## Plan Commission Agenda

City Hall Council Chambers  
203 S. Farwell Street, Eau Claire, WI 54701  
November 18, 2024, 6:00 PM

RE: SP-2414 – Plan Commission Site Plan Review

RE: SP-2415 – Plan Commission Site Plan Review

CIVIL SITE PLAN

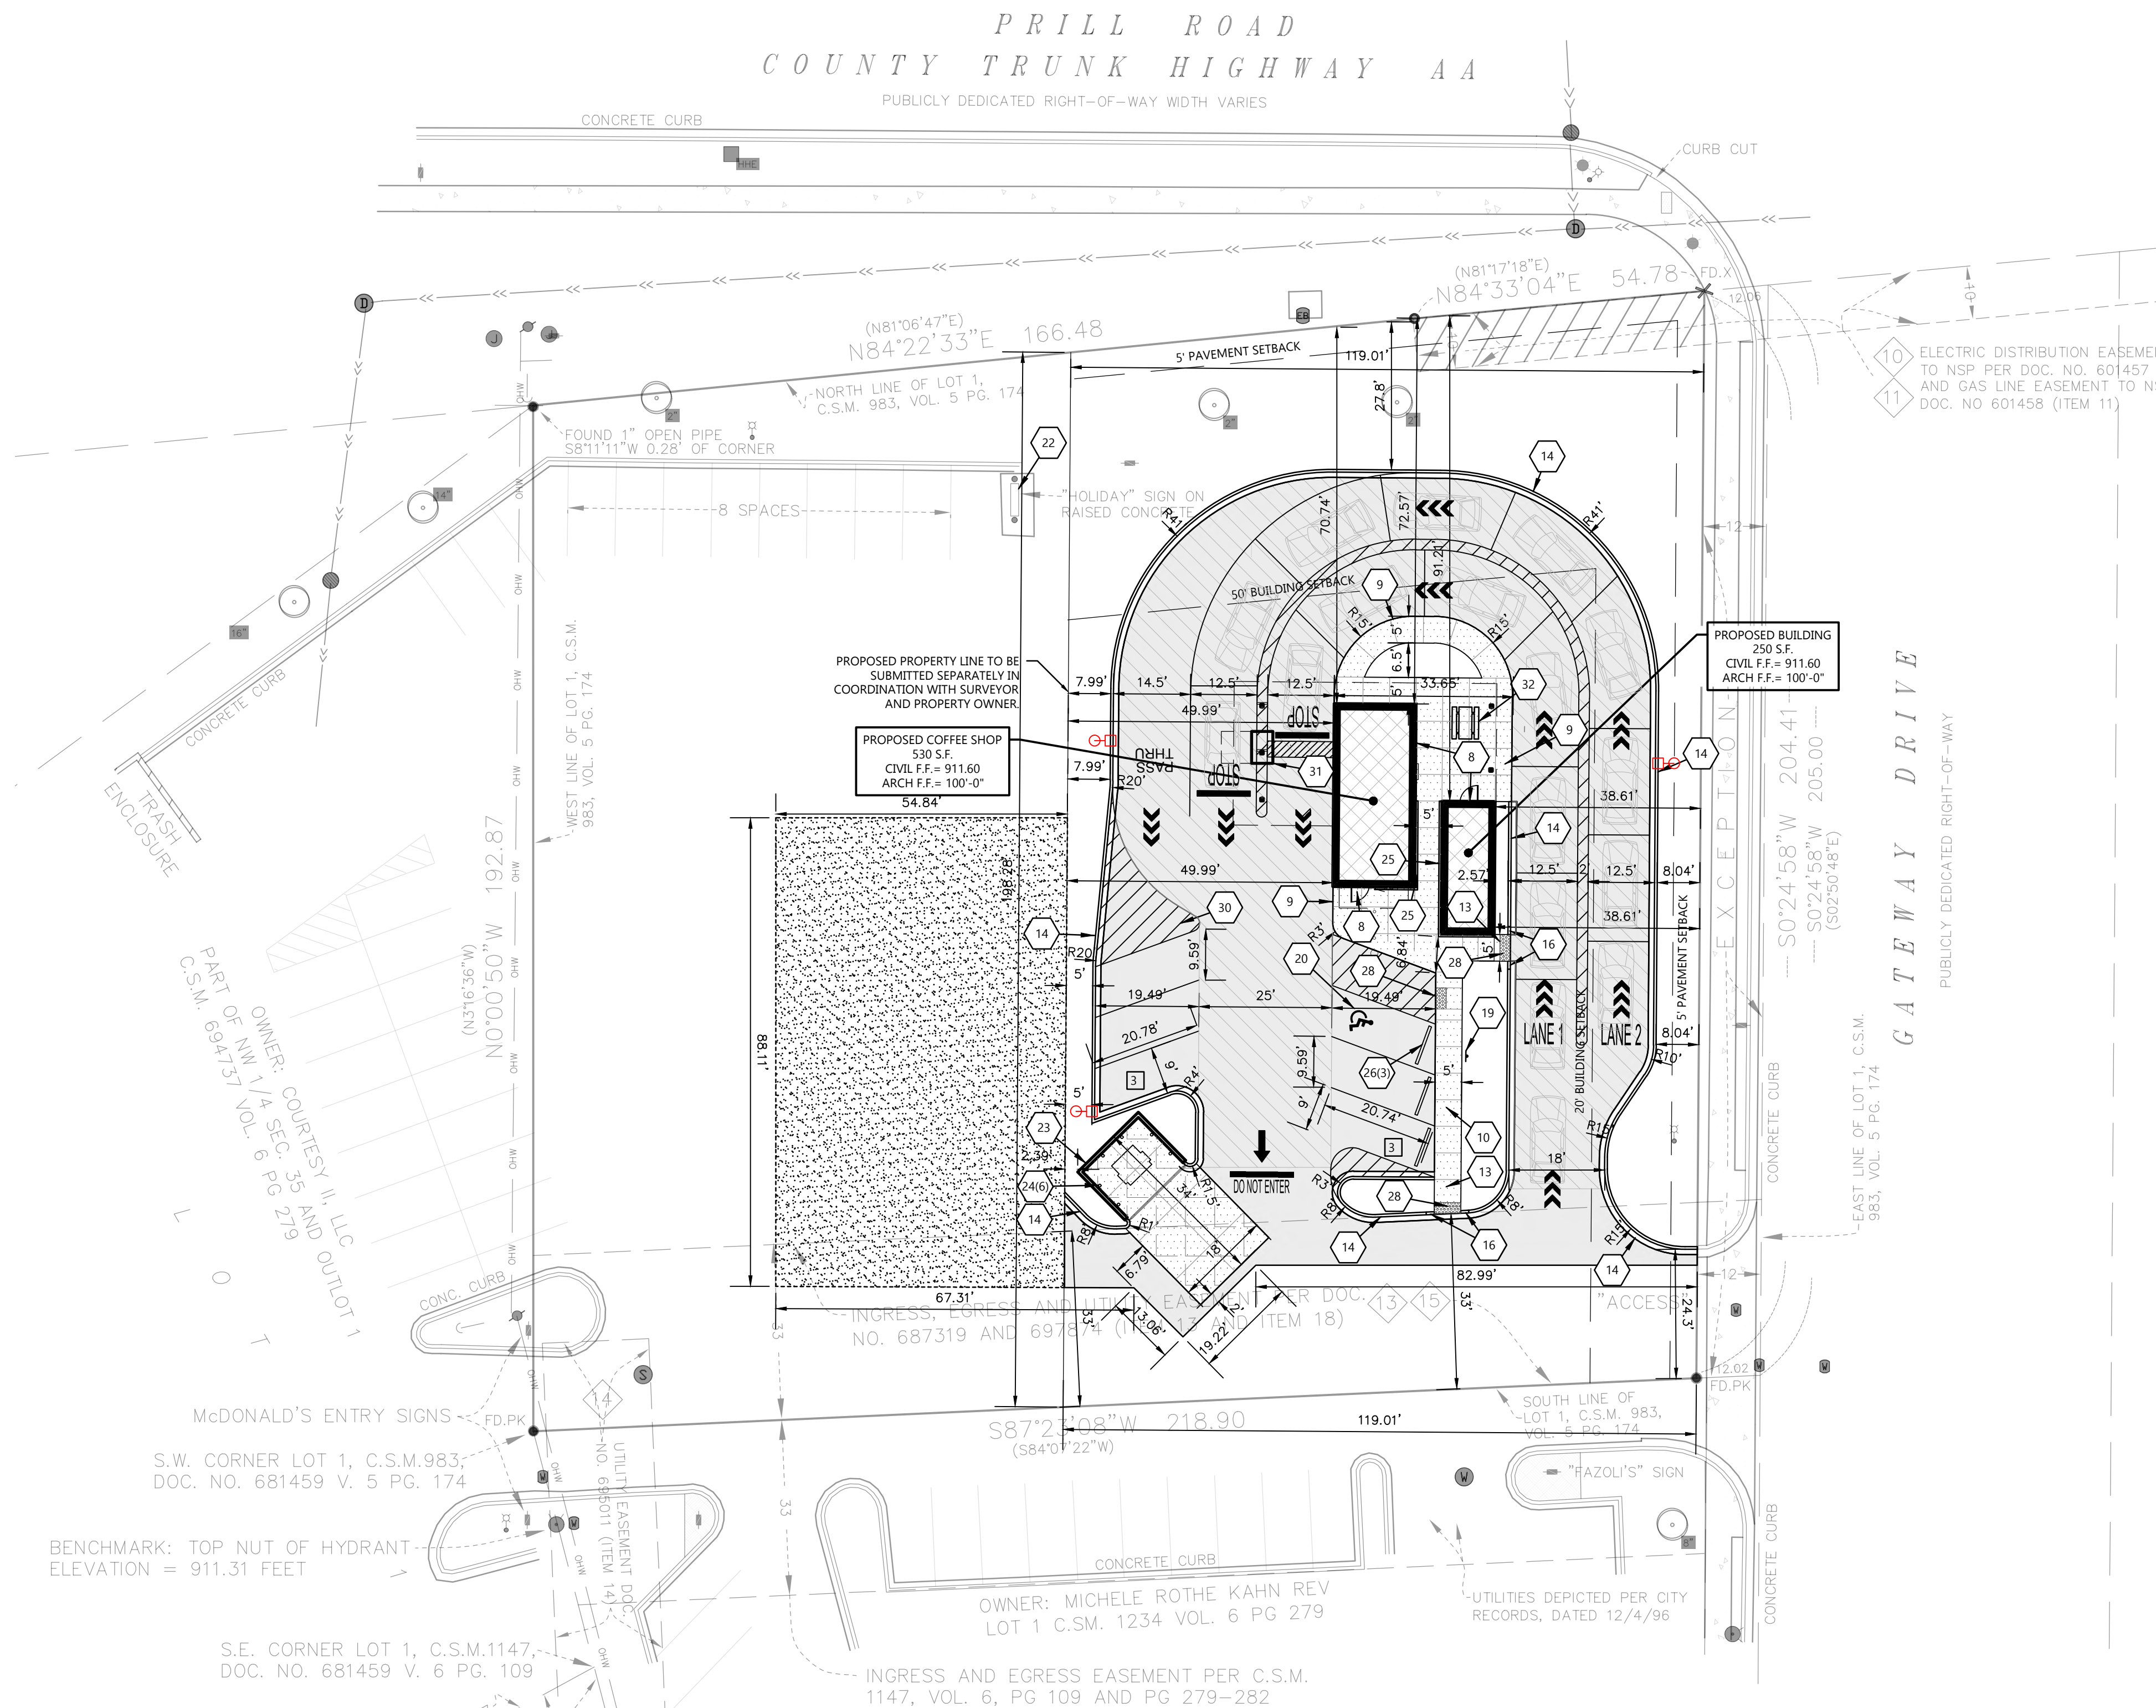
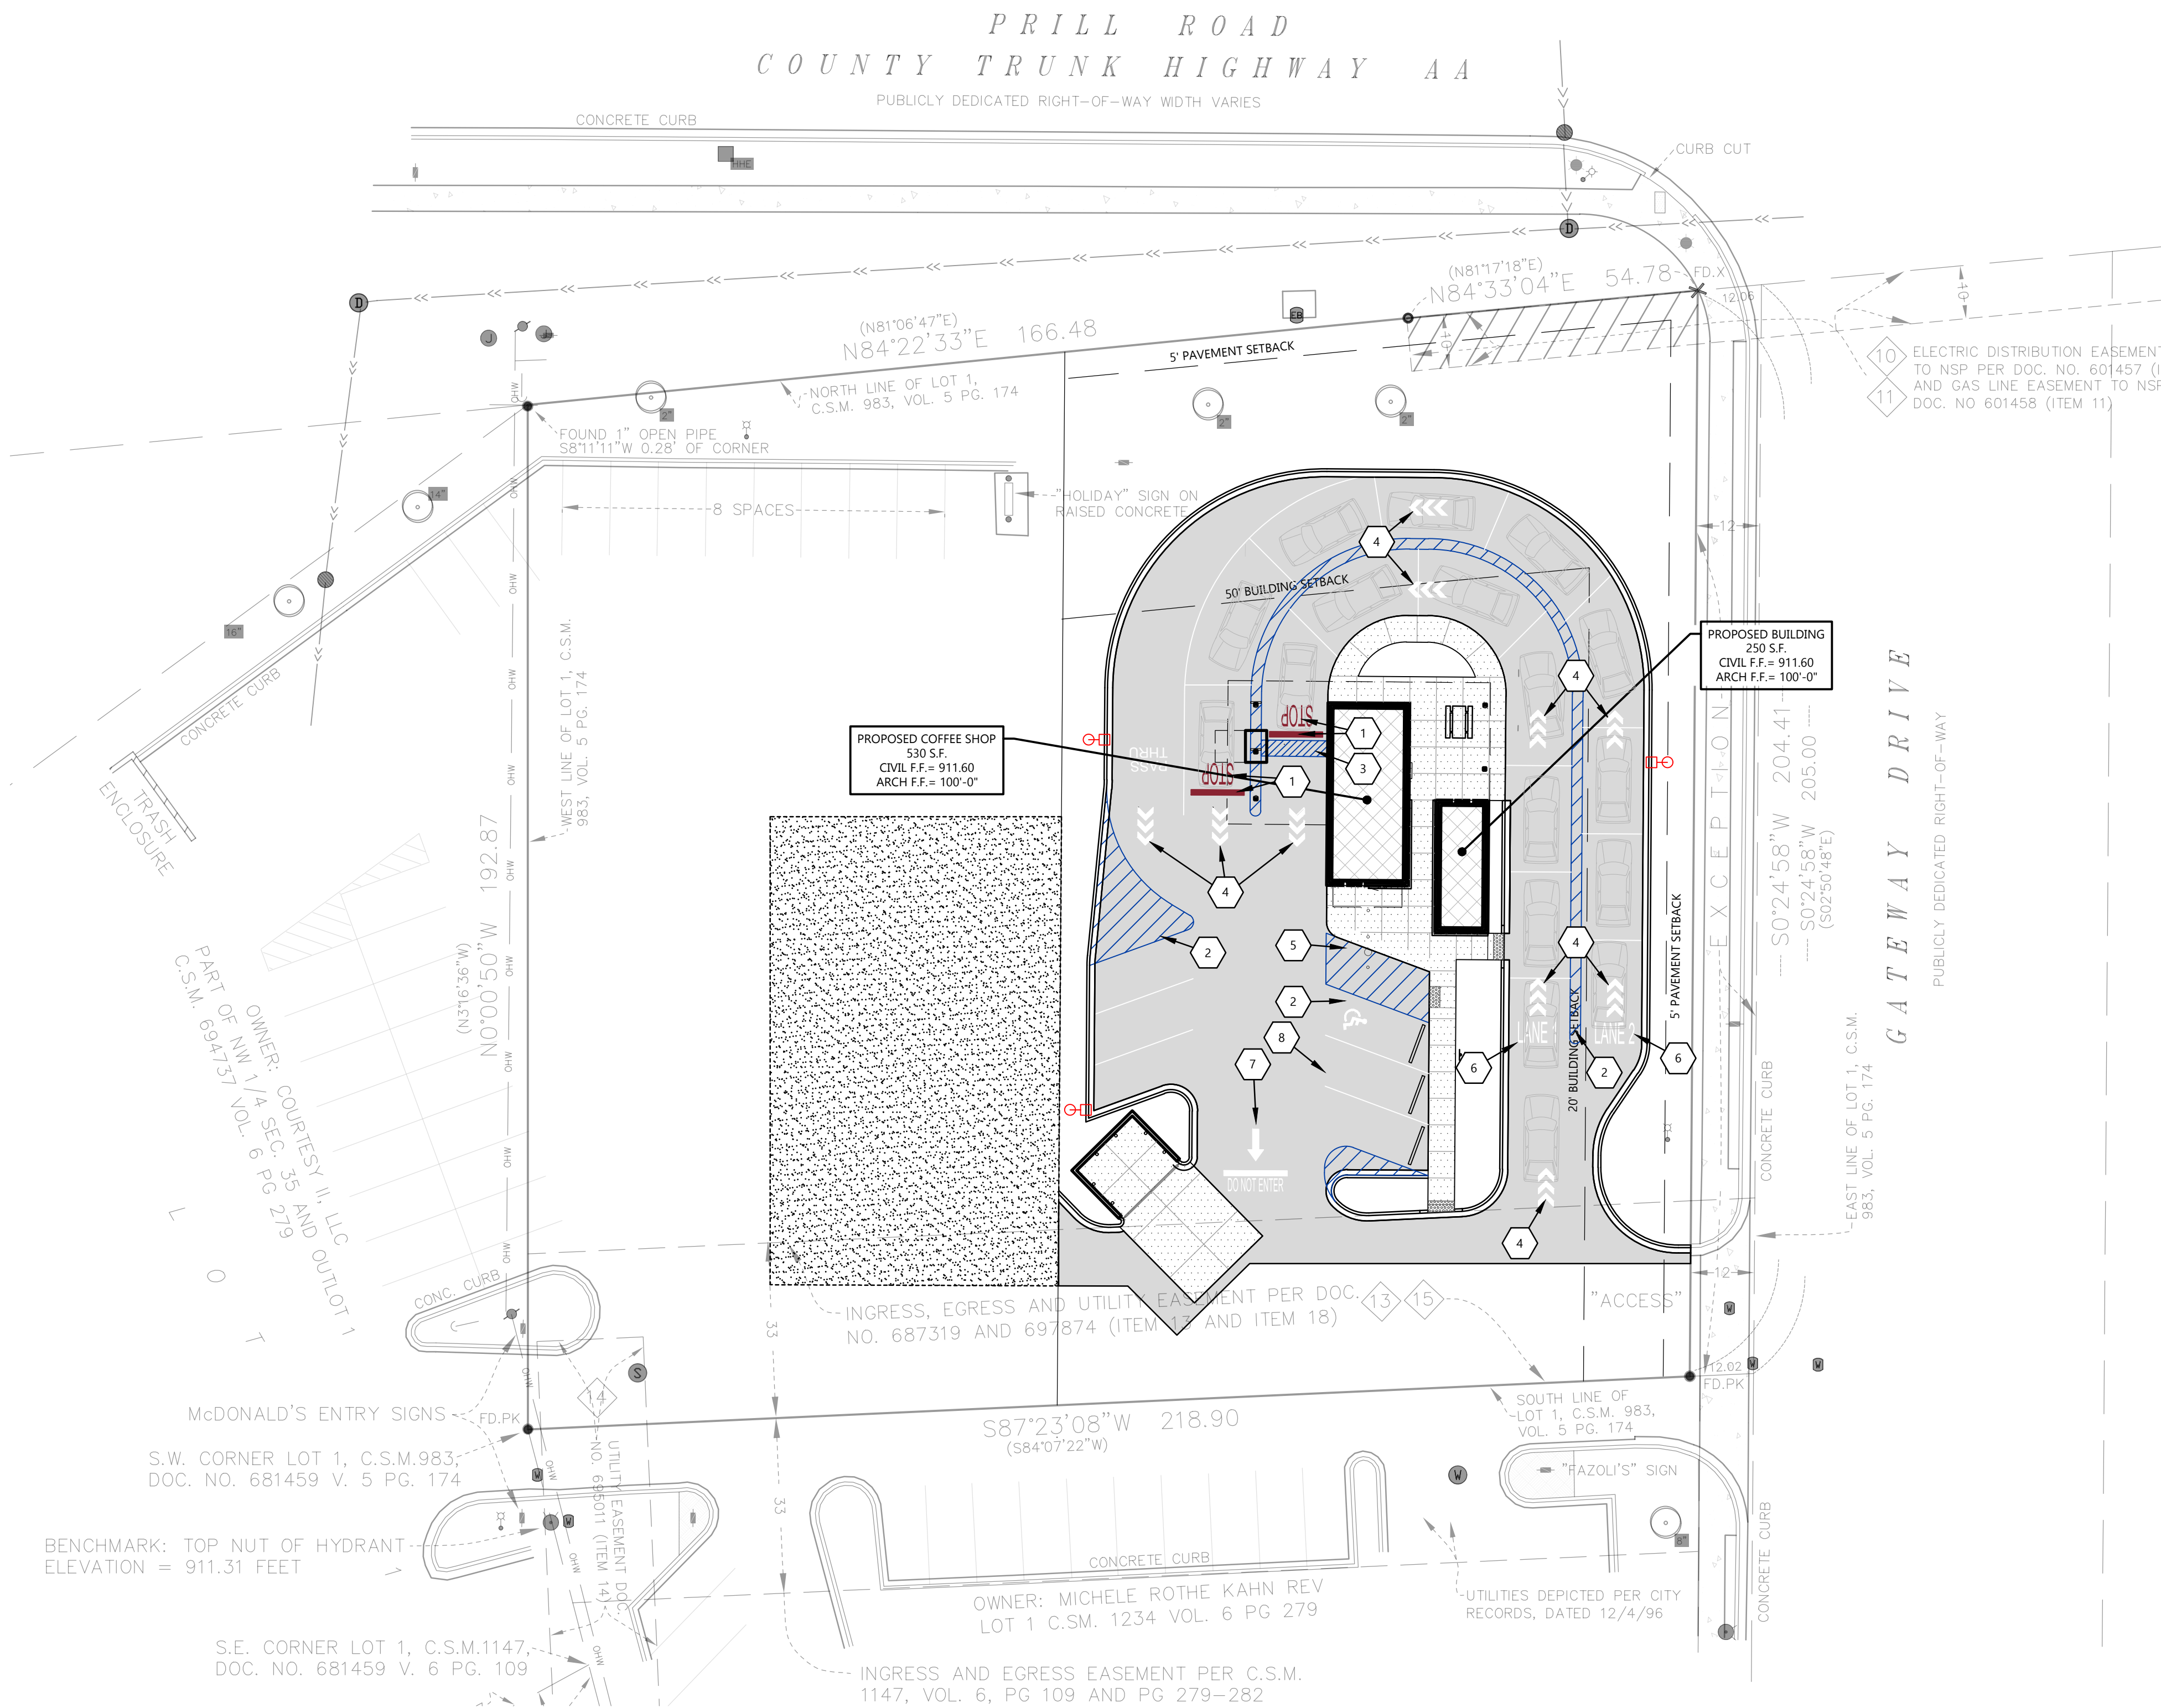
The applicant will need to provide the minimum of four (4) bicycle racks required under Section 18.25.031 A. 6. d). and the pedestrian access required under Section 18.45.050 F. as they are not shown in the submitted site plans. Staff would recommend connecting the coffee shop to the sidewalk along Gateway Drive by striping/paving a path from the ramp shown by the cooler in the site plan.

Along the northside of the parking lot, the applicant is saving the two of the existing trees, adding two more and providing a landscaping bed that spans the width of the proposed new paved area and four trees on the east side. To meet the required 1 tree per 30' lineal feet along Gateway Drive, they would need to provide three (3) more trees. However, considering the underground electrical line there, they should instead provide a landscaping bed like the one along the northern side of the parking lot. The architectural and landscaping plans depict the trash enclosure as being made of brick with a cedar plank gate. Outside of the enclosure they are proposing to plant six (6) evergreen trees with 2 on each side of the except the gated side.

With no immediate plan for construction on the west side of the property, under Section 16.04.300 C. the disturbed area (gravel field) would be required to be reseeded with four inches of black dirt and grass seed following the demolition of a structure. However, considering that the southern portion of the disturbed area is covered by an ingress/egress easement, staff requires that this portion be paved to better facilitate travel. This should be completed within 6 months of demolition.

1. Provide the minimum of four (4) bicycle racks required under 18.25.031 A. 6. D.
2. Provide pedestrian access to the site as required under Section 18.45.050 F.

3. Provide a landscaping bed along the east side of the drive lanes. It should be similar to the one provided on the north side and is in lieu of the three missing street trees.

4. The site plan must be revised to show the reseeding of the area proposed to be graveled with the exception of the area within the access easement, which should be repaved. This work should be completed within six months of demolition.

- a. This grassy area should not be incorporated into the equation for TSS reductions.
5. City of Eau Claire Engineering Department approval of drainage calculations, drainage plan, and maintenance agreement for best management practices.

- a. The submitted drainage calculations and grading plans should incorporate a 40% reduction in suspended solids.
6. Work with the City Engineering Department to perform a full Traffic Impact Analysis (TIA) addressing:
